## **LAFAYETTE PLANNING COMMISSION MEETING**

TO: LAFAYETTE PLANNING COMMISSION  
FROM: JIM JACKS, CITY PLANNER  
SUBJ: CONDITIONAL USE PERMIT  
CASE NUMBER CUP/SDR/PLA 2019-01  
DATE: MAY 23, 2019

TO: LAFAYETTE PLANNING COMMISSION  
FROM: JIM JACKS, CITY PLANNER  
SUBJ: SITE DEVELOPMENT REVIEW  
CASE NUMBER CUP/SDR/PLA 2019-01  
DATE: MAY 23, 2019

TO: LAFAYETTE PLANNING COMMISSION  
FROM: JIM JACKS, CITY PLANNER  
SUBJ: PROPERTY LINE ADJUSTMENT  
CASE NUMBER CUP/SDR/PLA 2019-01  
DATE: MAY 23, 2019

*Site Plan with Jefferson Street on the left (west), 4<sup>th</sup> Street on top (north) and Market Street on the right (east). Disregard the black arrows as they do not relate to the layout of the site.*

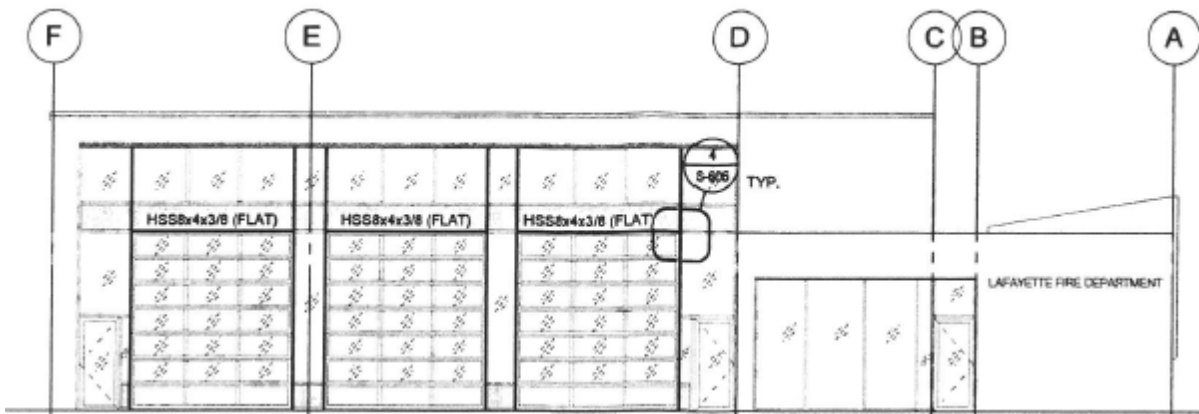
The plans provided to the City show 8 spaces on the Primary Site (7 regular spaces and 1 van accessible handicap space). Section 2.203.06 requires 1 handicap space where 1 – 25 spaces are required. The 1 handicap van accessible space meets the requirement.

**FINDINGS:** Criterion 2.203.08, G, does not apply to the Primary Site because the site plan shows no parking space will back-out or maneuver within Jefferson, 4<sup>th</sup> or Market Streets.

**FINDINGS:** The proposed fire station is “new development,” therefore, a minimum of 2 bicycle spaces shall be provided. The 2 bicycle parking spaces are not shown on the materials. A condition of approval requires a site plan be submitted prior to the issuance of a building permit showing the 2 spaces. With the condition of approval, 2.203.10, A, 1, B, is met.

**FINDINGS:** The 2 bicycle parking spaces are not shown on the materials within 100 feet of the building entrance. A condition of approval requires a revised site plan be submitted prior to the issuance of a building permit showing the 2 spaces are within 100 feet from a building entrance, within a well-lighted area and that they are clearly visible from the building entrance. The front or rear entrance will suffice.

ADA Compliance. The Americans With Disability Act (ADA) provisions are addresses above. The Site Plan shows one van accessible handicap parking space next to the fire station. ADA compliant plans are submitted, reviewed and approved at the Building Permit step.

3. A revised site plan shall be submitted prior to the city issuing a building permit showing a minimum of 2 bicycle parking spaces within 100 feet of the station, which are convenient and easy to find, in a minimum area of 2 feet by 6 feet for each space, with a minimum 5 foot wide access and that are secure, i.e., that comply with the applicable bicycle parking standards set forth in 2.203.10, A, 1, B and 2.203.10, B, 1 - 5.

*Landscape Plan with Jefferson Street on the left (west), 4<sup>th</sup> Street on top (north) and Market Street on the right (east).*

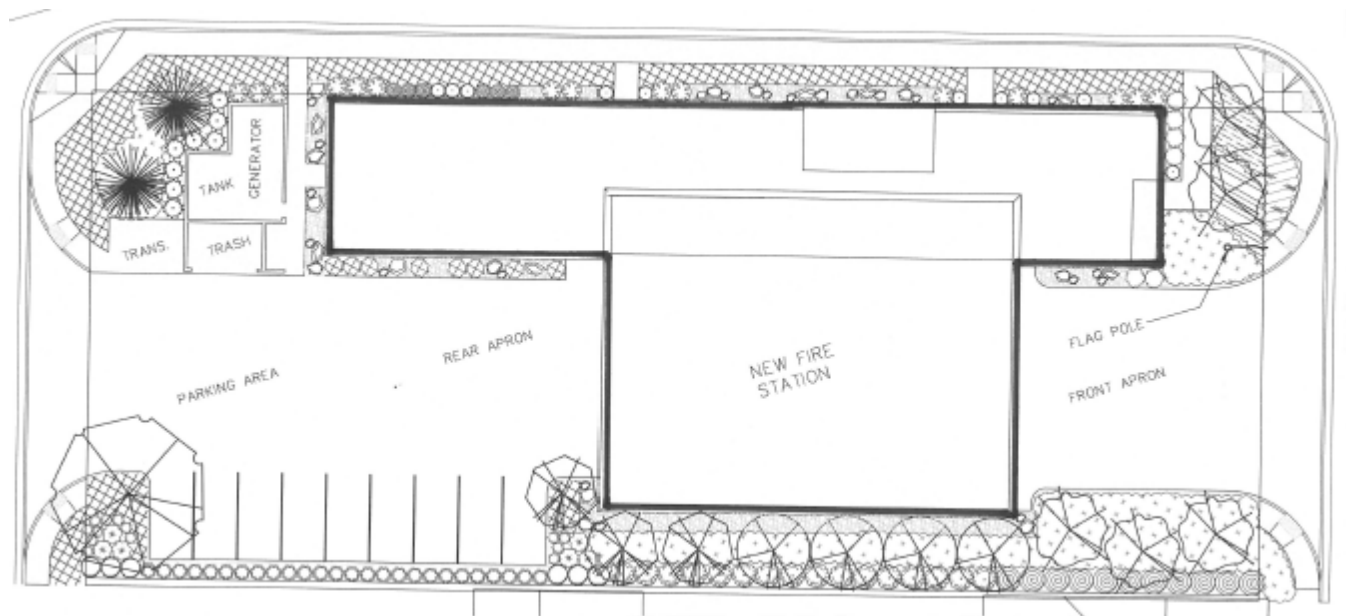
**FINDINGS:** The Landscape Plan shows all areas not containing structures or parking will be landscaped.

**FINDINGS:** The site is 24,000 square feet and 6% of the site equals 1,440 square feet. The Landscape Plan shows the site is heavily landscaped. For example, along the south property line is an approximately 600 square foot (5 foot x 120 foot) landscaped area between the row of parking spaces and the property line (SW corner of the site). Also, the area between the station and the south property line is about 1,800 square feet (15 feet x 120 feet) for a total just along the south portion of the site of 2,400 square feet which exceeds the required 1,440 square feet. Criterion 2.207.03, A, 2, is met.

**FINDINGS:** The Landscape Plan shows the parking lot landscape area not planted with trees are planted with shrubs and groundcover. Criterion 2.207.03, D, 3, is met.

**FINDINGS:** The Landscape Plan shows curbs along the edges of vehicle maneuvering areas. Criterion 2.207.03, D, 4, is met.

**FINDINGS:** The Landscape Plan's "General Deciduous Tree Planting Detail" shows trees planted within paved surfaces will be installed with root barriers. Criterion 2.207.03, D, 5, is met.
